SUNFLOWER LANDSCAPES
OFFICE / YARD
7620 MOHAWK ROAD
COLORADO SPRINGS, CO

JOB NUMBER	2790-0326
DATE	8/6/2026
DRAWN BY	MB
DRAWING DESCRIPTION	SITE PLAN - OVERALL
SHEET #	S-1

V3_Site Plan Drawing.pdf Markup Summary

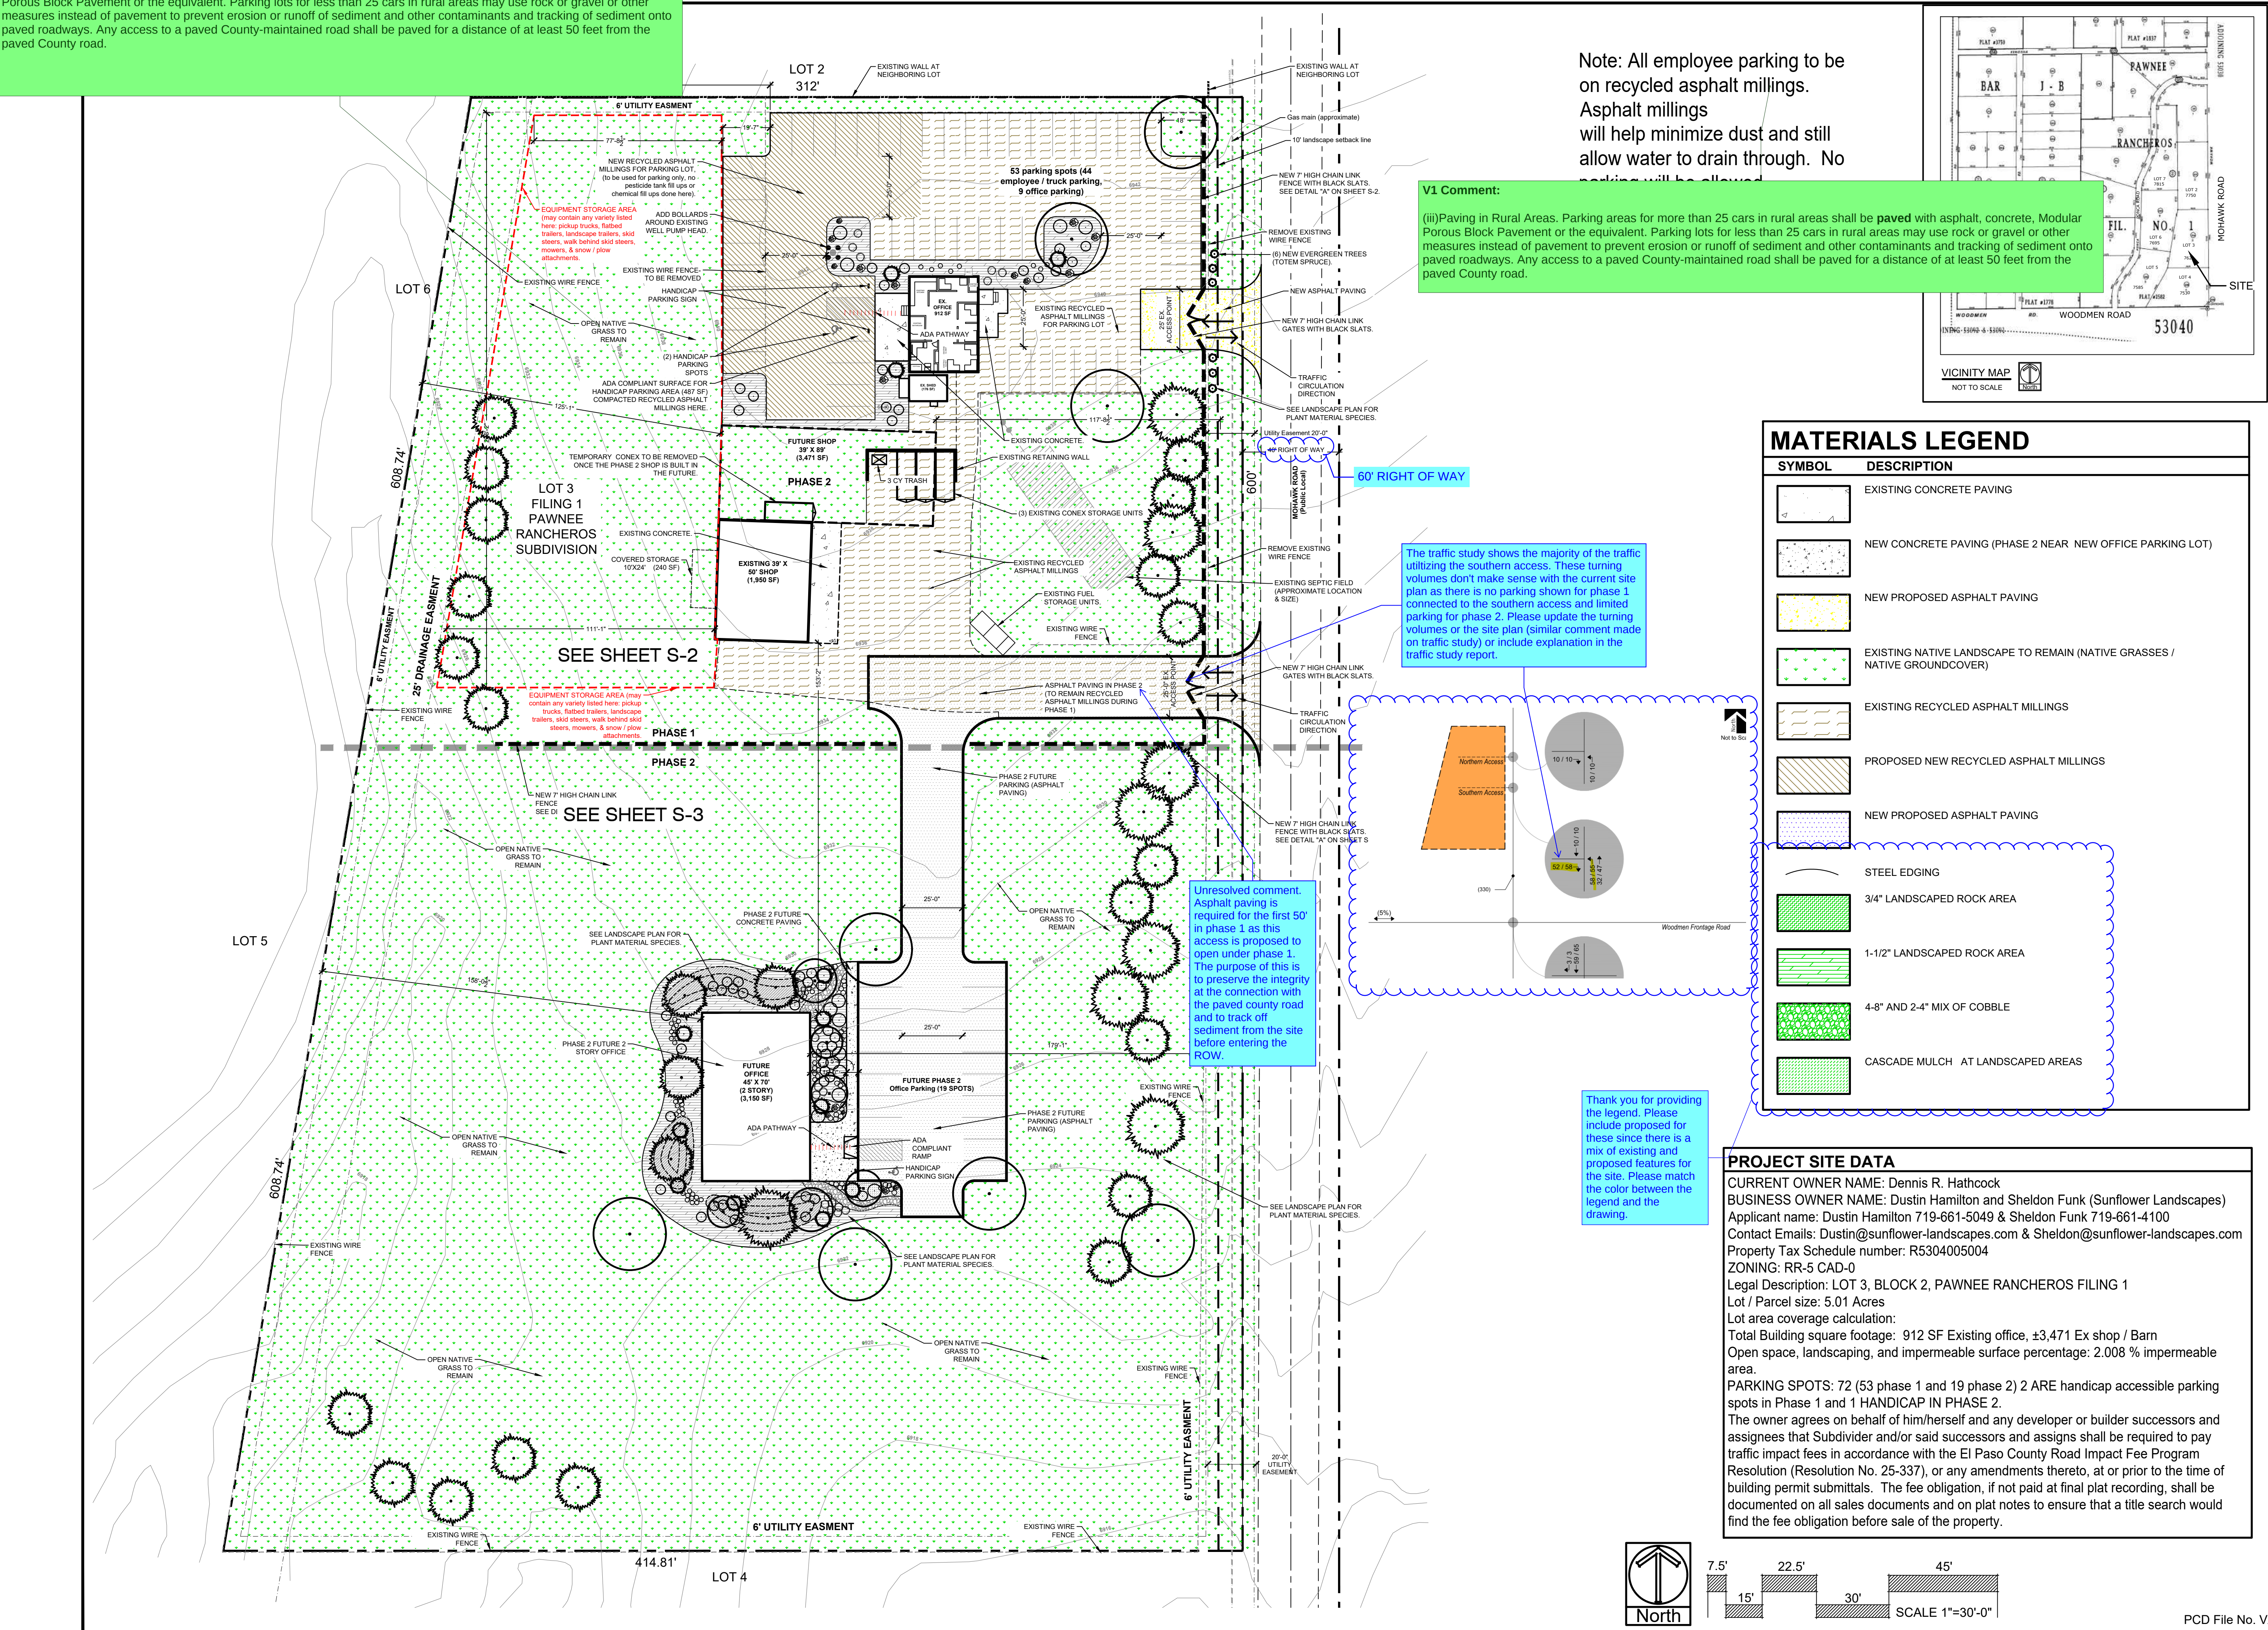
V1 Comment:

(iii)Paving in Rural Areas. Parking areas for more than 25 cars in rural areas shall be paved with asphalt, concrete, Modular Porous Block Pavement or the equivalent. Parking lots for less than 25 cars in rural areas may use rock or gravel or other measures instead of pavement to prevent erosion or runoff of sediment and other contaminants and tracking of sediment onto paved roadways. Any access to a paved County-maintained road shall be paved for a distance of at least 50 feet from the paved County road.

V1 Comment:

(iii)Paving in Rural Areas. Parking areas for more than 25 cars in rural areas shall be paved with asphalt, concrete, Modular Porous Block Pavement or the equivalent. Parking lots for less than 25 cars in rural areas may use rock or gravel or other measures instead of pavement to prevent erosion or runoff of sediment and other contaminants and tracking of sediment onto paved roadways. Any access to a paved County-maintained road shall be paved for a distance of at least 50 feet from the paved County road.

The traffic study shows the majority of the traffic utilizing the southern access. These turning volumes don't make sense with the current site plan as there is no parking shown for phase 1 connected to the southern access and limited parking for phase 2. Please update the turning volumes or the site plan (similar comment made on traffic study) or include explanation in the traffic study report.

Unresolved comment. Asphalt paving is required for the first 50' in phase 1 as this access is proposed to open under phase 1. The purpose of this is to preserve the integrity at the connection with the paved county road and to track off sediment from the site before entering the ROW.

Thank you for providing the legend. Please include proposed for these since there is a mix of existing and proposed features for the site. Please match the color between the legend and the drawing.
